UNITED STATES PATENT AND TRADEMARK OFFICE

APPLICATION NO.	FILING DATE	FIRST NAMED INVENTOR	ATTORNEY DOCKET NO.	CONFIRMATION NO.
09/839,001	04/20/2001	Harald Apfelthaler	KWO-17702/01	2739

Office Action Summary

DETAILED ACTION

INVENTOR.
JOHN A. DALLEN

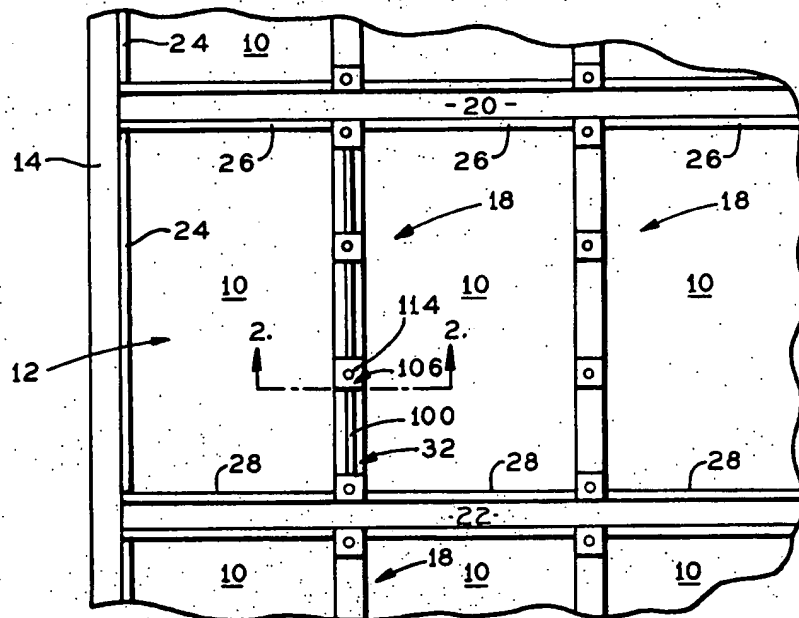
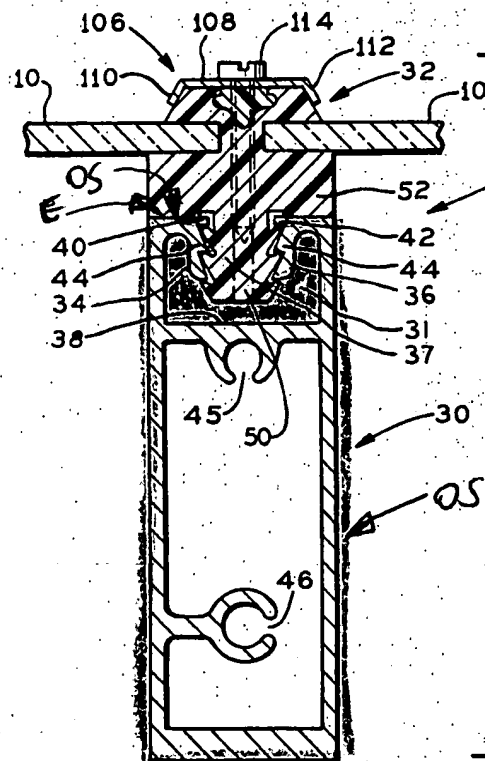
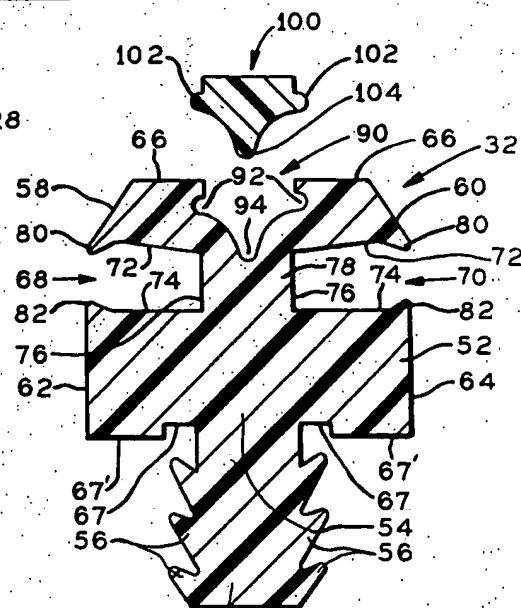
6. Claims 1-6,11,14,15 and 19 are rejected under 35 U.S.C. 102(b) as being anticipated by US Patent #3,766,698 to DALLEN. DALLEN discloses the use of a plug (32) in combination with a muntin (30) having an outer surface (OS, colored blue), an end (E), a hollow space (colored red), and inner walls (34,36), see the marked attachment; wherein, the plug (32)

includes a body (50) having a longitudinal slot (134), column 6, line 33-39 and column 7, line 20-30, that fits into the hollow space (colored red) of the muntin (30) and a flange (52) that is positioned on the outer surface (colored blue) of the muntin (30) and the plug body (50) press fits on the inner walls (34,36) of the muntin (30), column 6, line 33-39. In reference to claims 2-4, the slot (134) is coaxially aligned with the plug body (50); penetrates the plug body (50), see Figure 4; and receives a screw (114) that spreads apart the body (50), column 6, lines 33-39. Regarding claims 5,6,11 and 15, the slot (134) has a width/recess (90) at the upper end of the plug (32) different from the width (similar to 134) at the bottom end; wherein, the width/recess (90) is a groove that further includes a portion (92) also wider/greater than the width of the slot (134). In further regards to claims 14 and 19, the longitudinal slot (134) is coaxially aligned with the plug (32) and the body (50) includes a plurality of spring elements (56) extending therefrom that engage the inner walls (34,36) of the muntin (30).
